We are grateful for the opportunity to provide comments in advance of the June 28, 2017 Section 106 meeting concerning the most recent iteration of *The Weight of Sacrifice*, the World War I Memorial proposed for Pershing Park in Washington, D.C. We had a glimpse of this proposal – the so-called “[Restored Pool Concept](#)” – at the May 18, 2017 meeting of the U.S. Commission of Fine Arts (CFA), and subsequently in more detail on the National Park Service’s website. The design team is to be commended for its sympathetic treatment of the park’s perimeter. In fact, when the as-built plan for the [National Register-eligible](#) M. Paul Friedberg-designed Pershing Park is overlaid with the most recent proposal, many of the character defining features along the perimeter are retained.

# Exhibit A

## Pool Basin

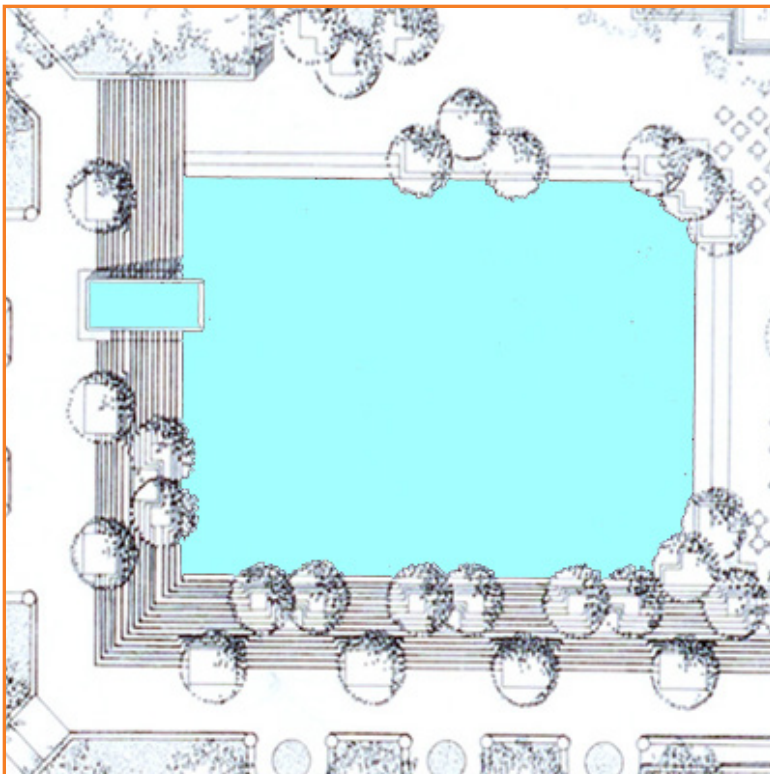
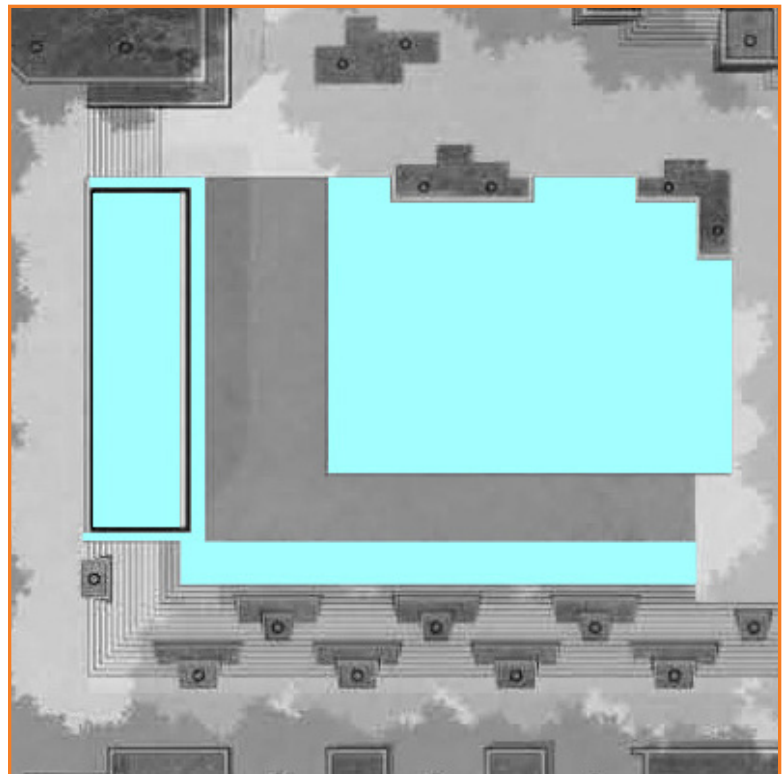
Regarding the pool, which is labeled as “restored,” the adverse effect is significant (for a comparison see Exhibit A as an Appendix to this letter). A new “L-shaped” path would be inserted within the pool’s existing footprint, reducing the pool’s surface area by some 40%, since the water would be replaced with hardscape. The depth of the remaining pool areas surrounding this new hardscape is ill-defined; it’s unclear whether the current depth will be maintained or would become a scrim or a combination of the two (for example, the walk area to the south of the pool basin, is shown dry in the rendering on page eleven, wet in the rendering on page fourteen, and shallow in the axonometric on page twelve). Whichever way, the integrity of the pool is significantly diminished. Moreover, according to the site plan of the proposed memorial, steps that currently lead down to the pool on the northern and eastern sides would be eliminated. By definition, that is not restoration.
